TOWN OF NEWBURGH PLANNING BOARD TECHNICAL REVIEW COMMENTS

PROJECT: A PLUS AUTO

PROJECT NO.: 18-17

REVIEW DATE: 15 FEBRUARY 2019 MEETING DATE: 21 FEBRUARY 2019

ROPE	VEYINC RTIF cessful Res tive Design	S,	Р	h: (845)	NY 12549 457-7727 457-1899
		SIT	E PLAI	V		-
A PLUS AUTO 12 LITTLE LANE ROAD TOWN OF NEWBURGH ORANGE COUNTY, NEW YORK				·		
JOB #:	1306.01	DRAWN BY	r: ML			
DATE:	09/06/18	SCALE:	1" = 30'	(1
REVISION 1 -	v: 01/31/19	TAX LOT:	53-4-4.21

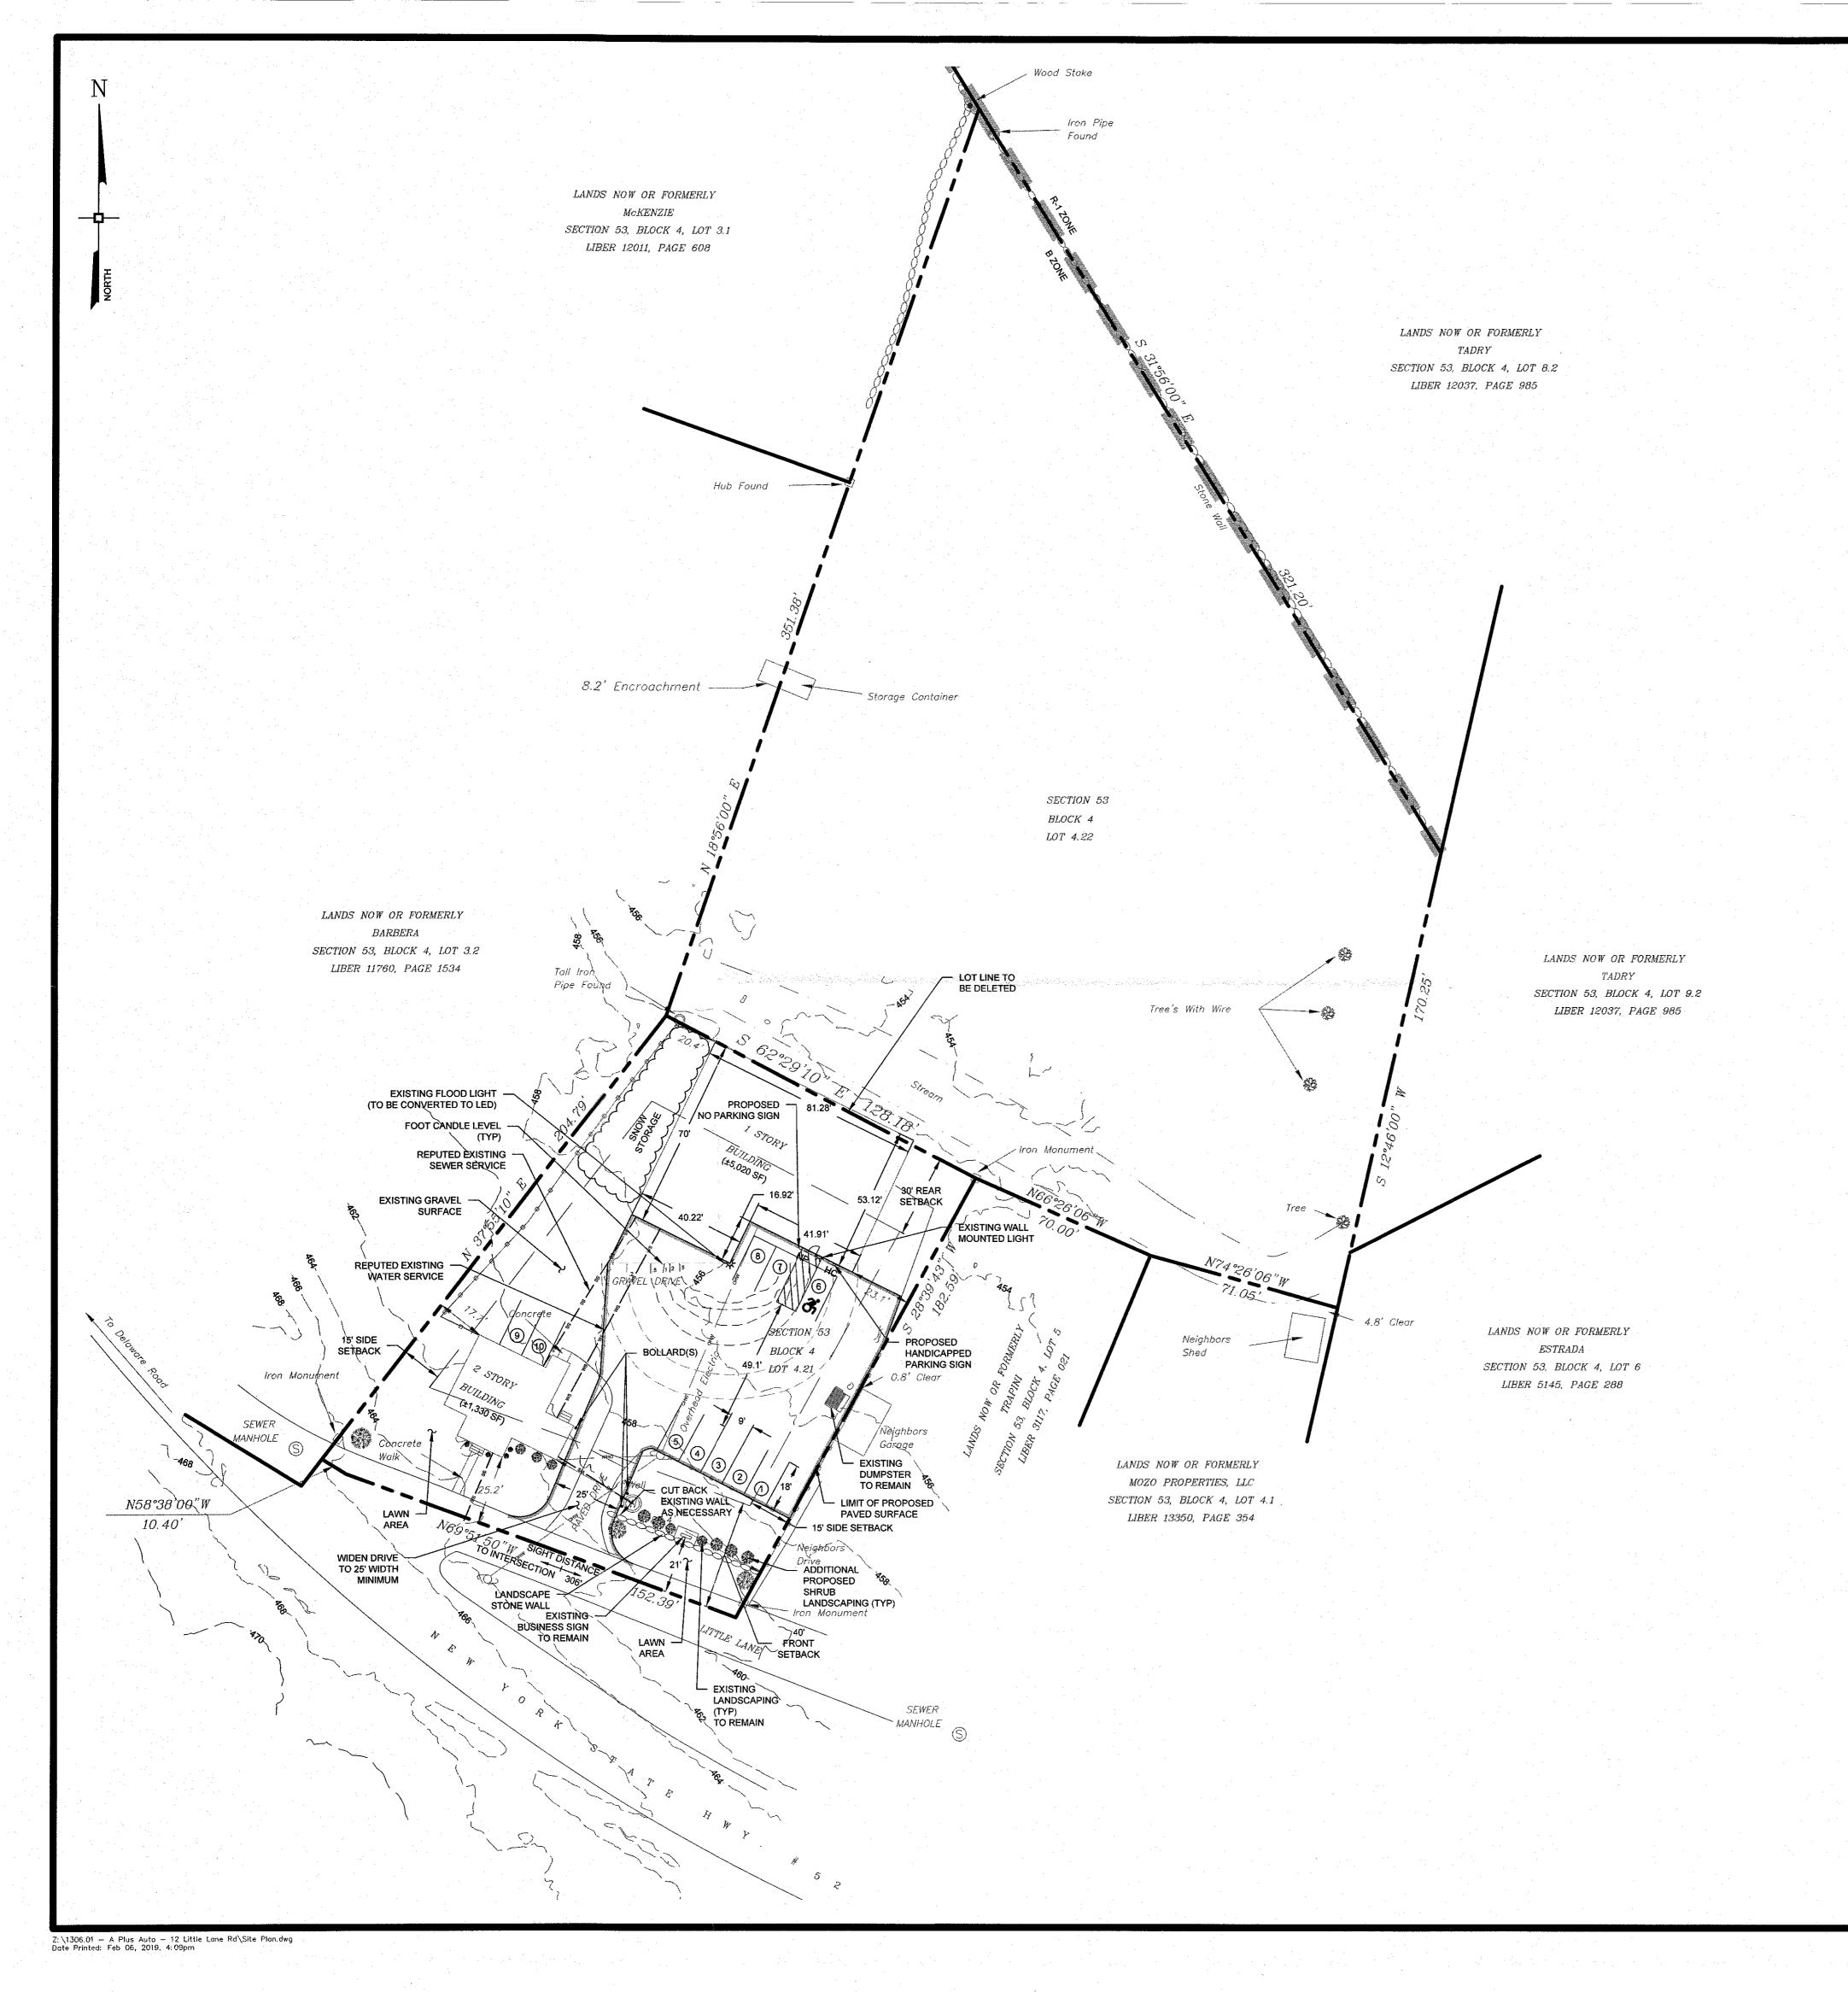
- **3.** Zoning Bulk Table should be modified in the lot surface coverage identified as 75% consolidation of the lots will significantly reduce the lot surface coverage.

- **4.** Planning Board should discuss whether curbing is required for commercial sites. Planning Board typically requires commercial sites to be curbed to control traffic flow and drainage.

- **5.** It is noted that Motor Vehicle Service Station notes have been added to the plans. Note #4 should be revised with the word "Parked" in lieu of "Parking".

- **6.** Applicants representative requested to address the dumpster enclosure currently a dumpster is depicted without benefit of an enclosure.
- **7.** It is noted that the site lighting is proposed to be upgraded to an LED flood light. The flood light is proposed to be designed with a motion activated sensor.

- **8.** Submission to Orange County Planning is required due to proximity to New York State highway. In addition project will be submitted to NYSDOT for SEQRA coordination.

- 1. A front yard variance was granted on January 24, 2019 by the Town of Newburgh Zoning Board. To achieve compliance with the rear yard setback the property owner is proposing to combine the subject parcel with the adjacent parcel to the rear in the same ownership. (lots 53-4-4.21 & 53-4-4.22). Proof of the lot consolidation will be provided prior to signature of the plans.

- The existing dumpster location is shown on the plan and labeled "to remain".
- 7. The property owner is in discussion with the building department with regards to the use of the residential building.

- 8. The entrance has been revised to indicate a width in accordance with Section 185-28, in addition "Motor Vehicle Service Station Notes" have been added to sheet C-1.

- 9. Proposed landscaping has been added to the plan.
- 10. Dimensions and areas for the structures have been added to the plan. The property owner is pursuing a variance from requiring a sprinkler system.

- 12. Parking spaces 1 through 8 will be painted in accordance with the detail on sheet C-2. Spaces 9 & 10 are depicted to show compliance with the Town parking requirements but will not be painted as they are located within an existing gravel area.
- 13. Lighting details and footcandle levels have been added to the plans.
